FEASIBILITY STUDY ON THE
PROPOSED DRAINAGE DITCH RELOCATION
AT SUNRAY SERVICES SITE 3
TONTITOWN, ARKANSAS

Re: Drainage Ditch Modification, Sunray site 3.

Recently, Sunray Services, Inc. encountered pre-existing trash south of station 7+00 in the area where the approved (May, 1989) western drainage ditch was to be excavated. Sunray Services, Inc. is requesting that a minor permit modification be granted by ADPC&E regarding the western drainage ditch at Sunray site 3.

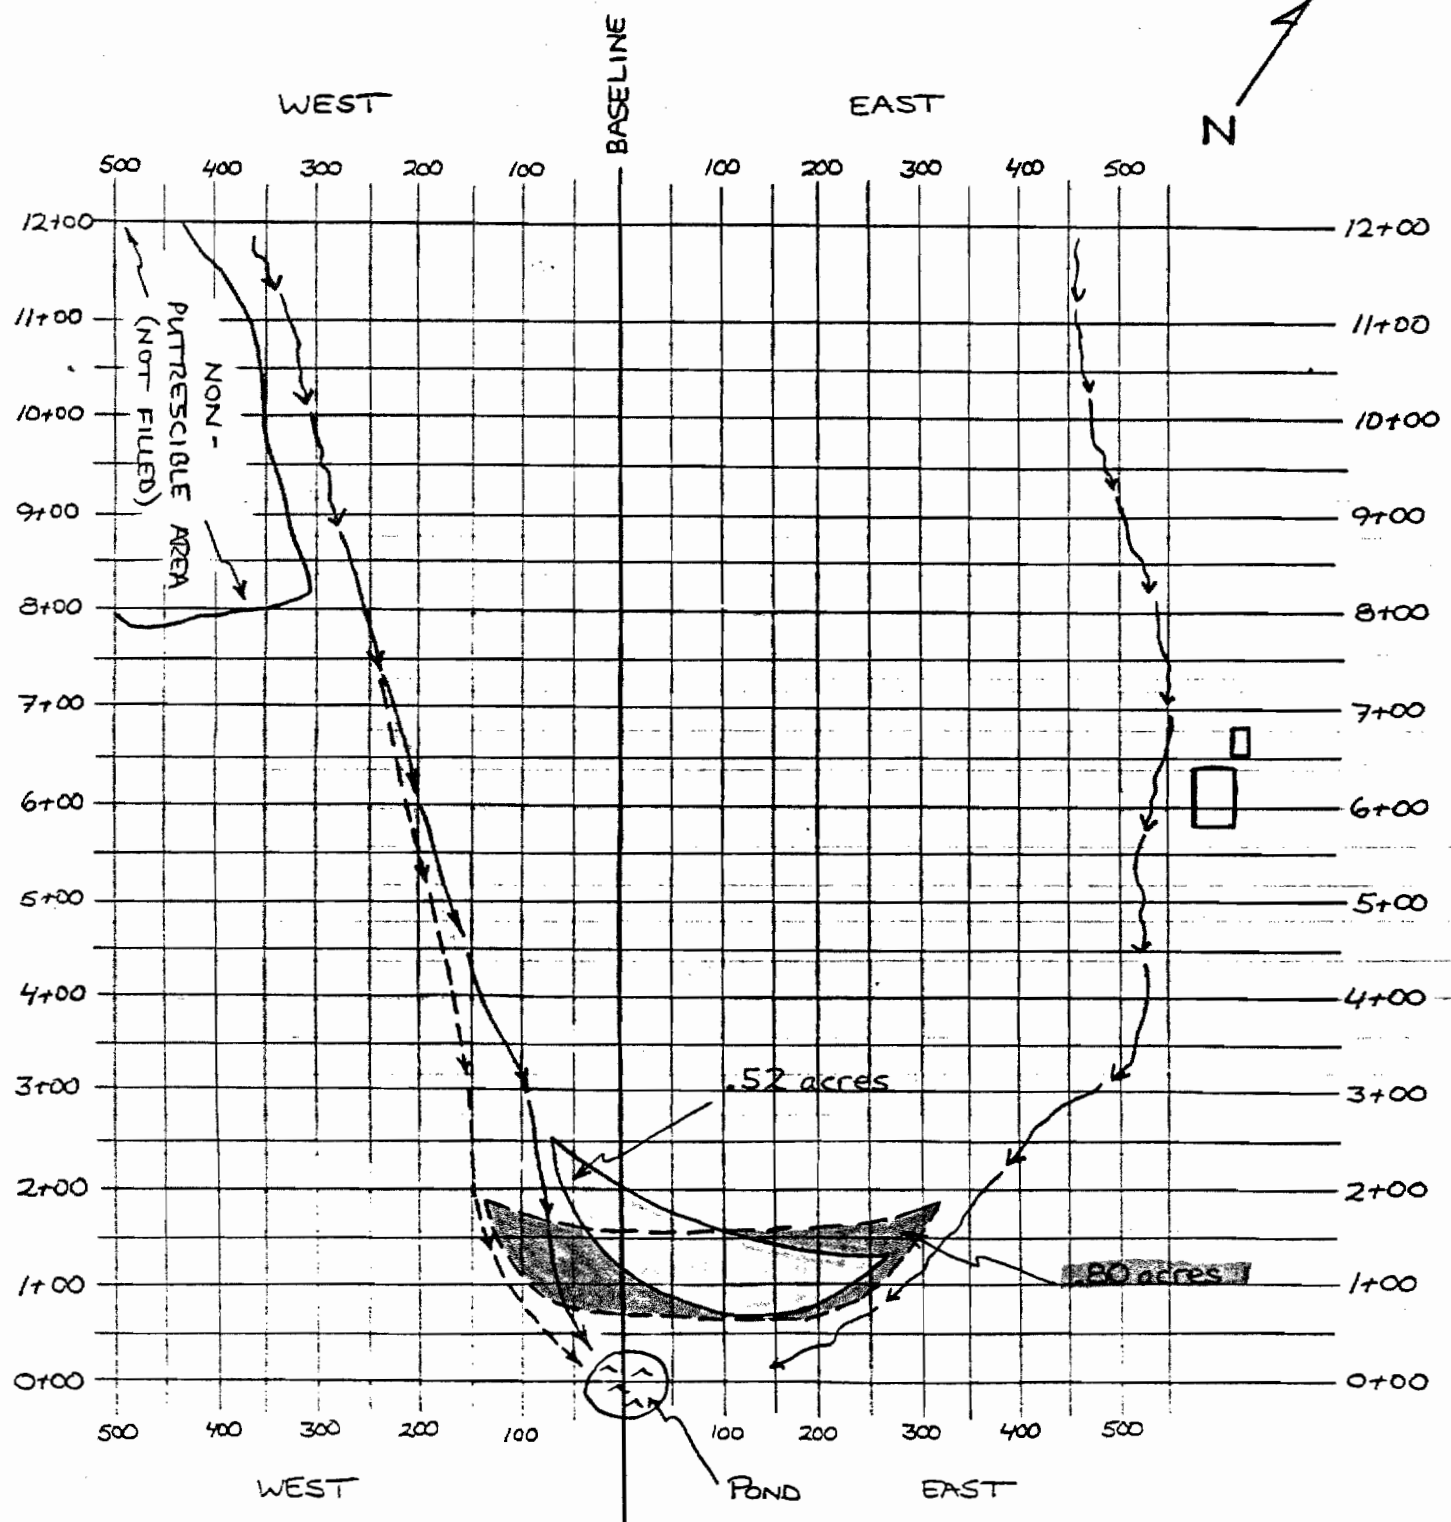
The above reduction in slopes would create additional air-space over existing slopes and in the 0.42 acre expansion, as shown in Appendix A. Voids ≤ 1 foot would occur over an area of ~0.78 acres (see Sheet 2) and would be filled in with soil only. All remaining voids (≥ 1 foot) would occur over

~1.25 acres (see Sheet 2) and would be filled in with an average 1.5 foot thickness of trash and a 6 inch daily soil cover.

Shifting of the landfill berm (to be discussed later) would generate no additional air-space, as shown on Sheet 2.

As previously mentioned, infilling of the additional air-space would require 6 inches daily cover over trash placed in an area of ~1.25 acres, and soil only in ~0.78 acres, as shown on Sheet 2 and in Appendix A. The average infill thickness in the latter area is also 6 inches. Therefore, ~2.03 acres would require 6 inches soil, which is equivalent to ~1,638 CY.

Shifting of the landfill berm (to be discussed later) would generate no additional air-space and will therefore not require additional daily cover soil (see Sheet 2).

Shifting the landfill berm (to be discussed next) does not alter existing final cover requirements (see Sheet 2).
